# Product Change Notification

Product Change Notification: P-15-011368

Modular Plugs (6, 8 and 10 position) Commonly referred to RJ

**Universal Contact Isometric Drawing**

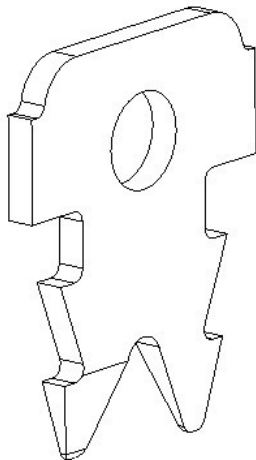
TE Connectivity is proud to announce that on or about July 1, 2015 we will be introducing and going into production with a new universal contact on the modular plug family. Presently the TE Connectivity modular plug family utilizes two different contacts, one for stranded wire and another one for solid wire, resulting in two different modular plugs. In July 2015 this will change to a single version modular plug using a contact designed to be used on either stranded or solid wires. TE Connectivity will be discontinuing its present offering of modular plugs on or about October 1, 2015 depending upon inventory consumption. All present modular plug part numbers for both solid and stranded modular plugs will be discontinued and replaced with a new part number for the modular plug using the universal contact. Please see the attached Frequently Asked Question (FAQ) that answers additional questions plus also provides a comprehensive cross reference.

Product improvement. This significant engineering and tooling investment was undertaken based on the voice of the customer desiring only one version of contact and resulting modular plug to reduce inventory management and availability concerns. Additionally TE Connectivity development has insured that the new universal contact has equal or better reliability on both wire types. The new version has several advantages over the present modular plug. They are: reduced inventory management concerns replacing two parts with one, increased availability with reduced lead-times and increased reliability of wire-to-contact interface. There are no limitations or disadvantages to the new universal modular plug other than managing the transition phase from existing to new and the associated part number changes. There are no changes to the application tooling either for the hand-tools or semi-automatic machines. There are no changes to installation procedures.
